**8561EC-04**

# S E R V I C E N O T E

## 856xEC Series Portable Spectrum Analyzer

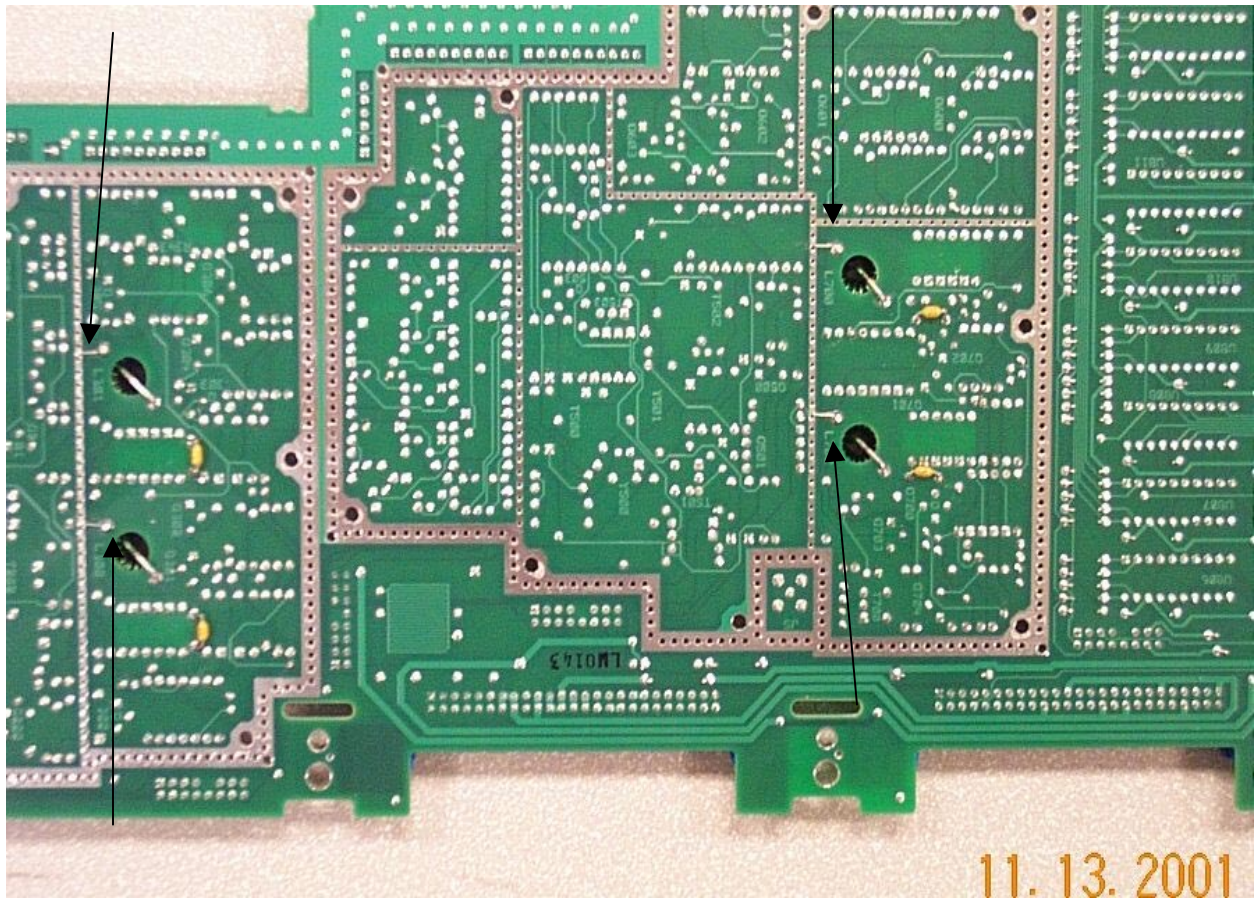
For the instruments specified above, inductors within the A5 IF assembly are not making good connections to ground thereby giving error messages related to the A4 Log Amp board. Error numbers that appear in the lower right-hand corner of the screen on account of this problem are errors 561, 562, and 565.

If the serial number of the instrument applies to the ones above, the following butch may solve the problem. Remove the shielding from the A5 IF assembly. Locate the inductors, and according to the attached photograph, insert and solder one end of the 8150-4222 wire into the hole connecting to the inductors and solder the other end to the ground plane on the front layer of the board. Do this for each inductor. See attached picture, the arrows point to where the jumpers are attached.

Add jumpers according to the picture above.
